**Technical Specifications Task Force  
Improved Standard Technical Specifications Change Traveler**

**Correct RPS Bases for MSIV and TSV Functions**

NUREGs Affected:  1430  1431  1432  1433  1434  2194

Classification: 2) Bases Only Change

Figure 1  
RPS Logic for the MSIV – Closure Function

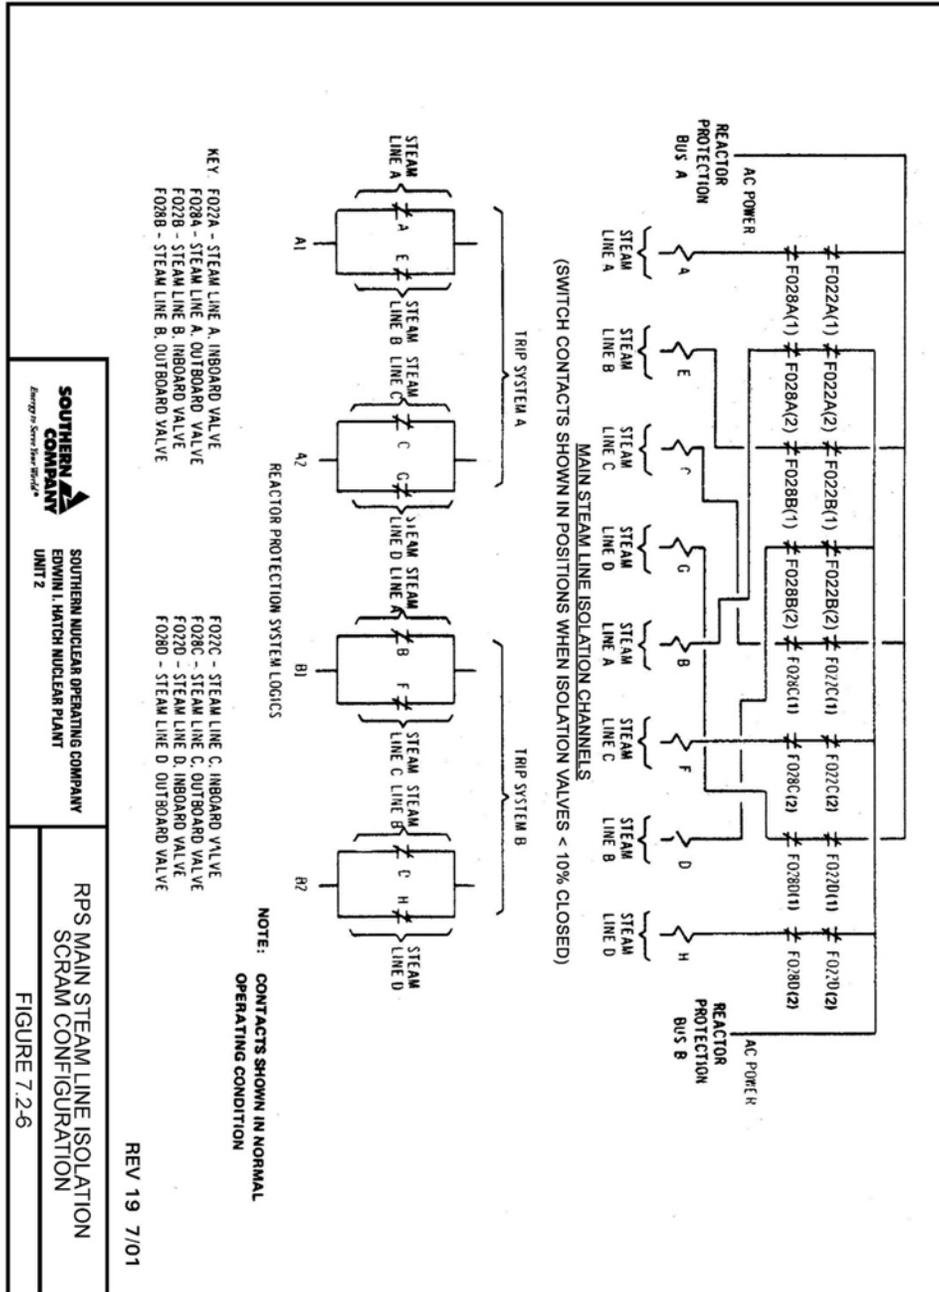
The RPS logic for the MSIV – Closure Function is shown on Figure 1 (although it is from the Hatch Final Safety Analysis Report, it is representative of the logic for the BWR designs). The A and B RPS trip systems each have two trip logics. Each trip logic contains output contacts from two of the four MSL channels (The vendor design documentation refers to the MSLs as “channels”) configured in parallel. The logic is 1-out-of-2-taken twice, which means one of the two trip logic relay closing coils must de-energize in each trip system trip to product a scram. Having any three MSL channels operable in both trip systems will ensure trip capability. From the vendor design documentation, the basis for this arrangement is to allow one MSL to be taken out of service (i.e., the MSL is isolated) without either causing or preventing a scram. This is unrelated to the single failure criteria. There is no single failure that would cause any single MSL to not isolate on a valid signal. However, it should be noted that with one MSL out of service, the RPS trip system is no longer single failure proof. This design feature was inappropriately described in the Bases of Required Action C.1 as requiring three operable MSL channels per trip system (not necessarily the same MSL in each trip system) as the minimum functional capability. The problems with these Bases statements are: 1) it was never part of the logic design feature that different MSLs could be operable in both trip systems, and 2) this creates an implication over and above the single failure criterion that trip capability requires the postulation of any single MSL to close. This is not required by IEEE-279-1971, “Criteria for Protection Systems for Nuclear Generating Stations,” and is overly restrictive. It can readily be seen on Figure 1 that only two MSL channels associated with one trip logic in each trip system are required to maintain trip capability. However, the proposed parenthetical statement in the Bases describes the design feature that the closure of at least three MSLs are required to produce a scram.

MSIV closure signals are initiated from position switches located on each of the eight MSIVs. Each MSIV has two position switches; one inputs to RPS trip system A while the other inputs to RPS trip system B. Each inboard and outboard MSIV inputs to a main steam line channel in each trip system, and each of the two trip logics within each RPS trip system receive parallel inputs from two of the four main steam lines. Thus, each RPS trip system receives an input from eight Main Steam Isolation Valve - Closure channels, each consisting of one position switch. The logic for the Main Steam Isolation Valve - Closure Function is arranged such that either the inboard or outboard valve on both three or more of the main steam lines in one of the two trip logics in each RPS trip system must close in order for a scram to occur.

**Figure 2**  
**RPS Logic for the TSV – Closure Function**

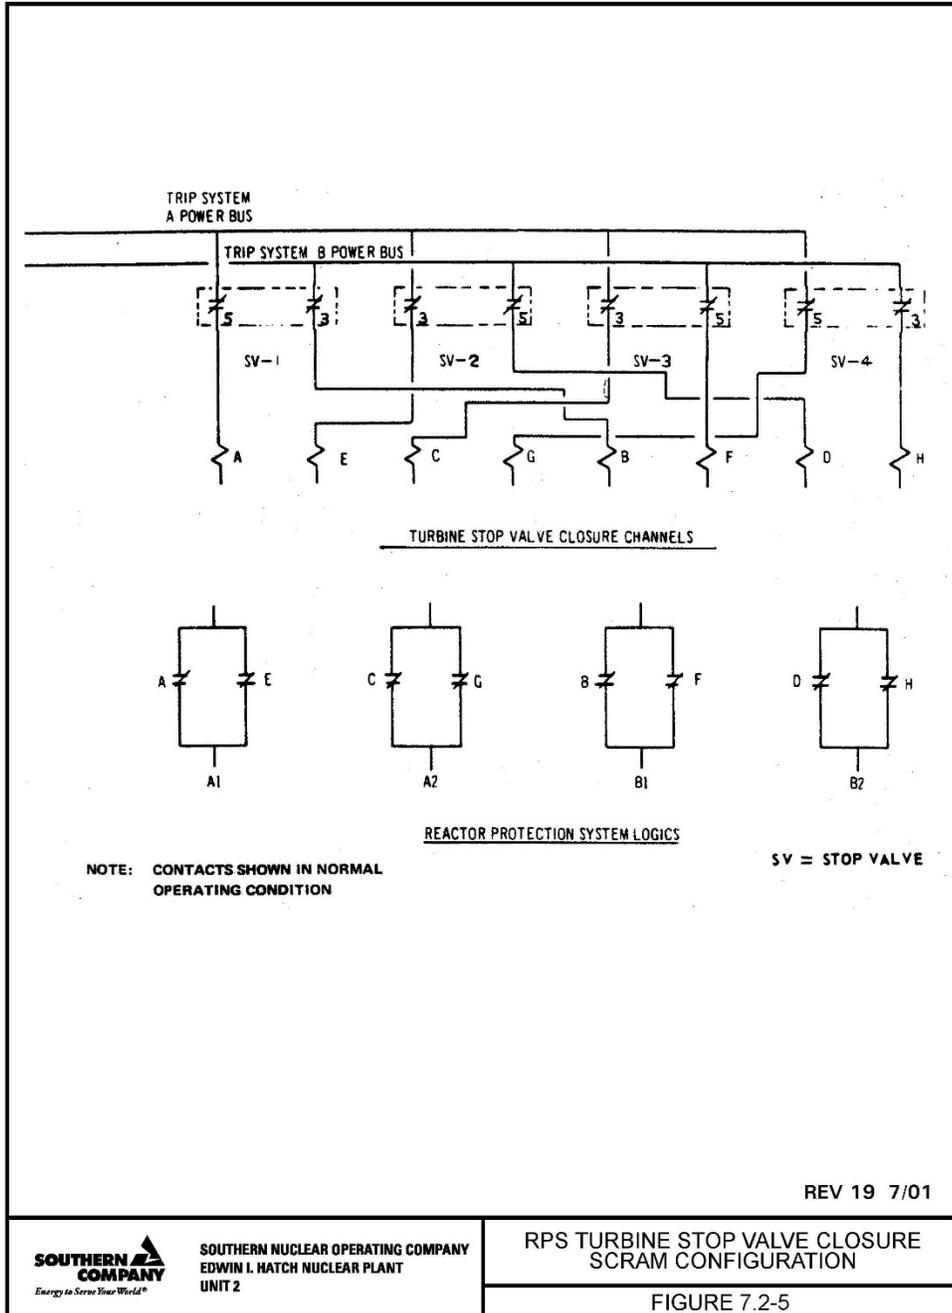
Similarly, the RPS logic for the NUREG-1433 TSV – Closure and the NUREG-1434 TSV Closure, Trip Oil Pressure – Low Functions is shown on Figure 2. The A and B RPS trip systems each have two trip logics. Each trip logic contains output contacts from two of the four TSV channels configured in parallel. The logic is 1-out-of-2-taken twice, which means one of the two trip logic relay closing coils must de-energize in each trip system trip to produce a scram. Having any three TSV channels operable will ensure trip capability, although this configuration is no longer single failure proof. This design feature was described in the Bases of Required Action C.1 as requiring three operable TSV channels per trip system as the minimum functional capability. This would be valid if the single failure criteria were applicable. However, as stated in the C.1 Bases, this Required Action is for conditions where multiple, inoperable, untripped channels in one trip system exist. Under such conditions, single failure criteria is not applicable (i.e., the time spent in this condition is limited by the TS Action). Absent considerations of single failure, it can be seen on Figure 2 that only two TSV channels associated with one trip logic in each trip system is required to maintain trip capability. Consistent with the MSIV – Closure Function, a parenthetical statement is inserted in the Bases to describe the design feature that the closure of at least three TSVs are required to produce a scram.

This wording is subject to misinterpretation, as it can be read to imply that trip capability is maintained with a failure of a TSV to close combined with an additional single instrument failure. It can be seen on Figure 2 that trip capability is not assured with that combination of failures. The wording is revised to be consistent with the analogous discussion of the MSIV – Closure function.

Turbine Stop Valve - Closure signals are initiated from position switches located on each of the four TSVs. Two independent position switches are associated with each stop valve. One of the two switches provides input to RPS trip system A; the other, to RPS trip system B. Each of the two trip system logics within each RPS trip system receive parallel inputs from two of the four turbine stop valves. Thus, each RPS trip system receives an input from four Turbine Stop Valve - Closure channels, each consisting of one position switch. The logic for the Turbine Stop Valve - Closure Function is such that two three or more TSVs in one of the two trip logics in each RPS trip system must be closed to produce a scram.

For Function 8 (Turbine Stop Valve - Closure) [Function 9 Turbine Stop Valve Closure, Trip Oil Pressure - Low], this maintaining RPS trip capability would require at least one trip system logic in both trip systems to have two ~~three~~ channels (at least three different turbine stop valves total for both trip systems), each OPERABLE or in trip (or the associated trip system in trip).
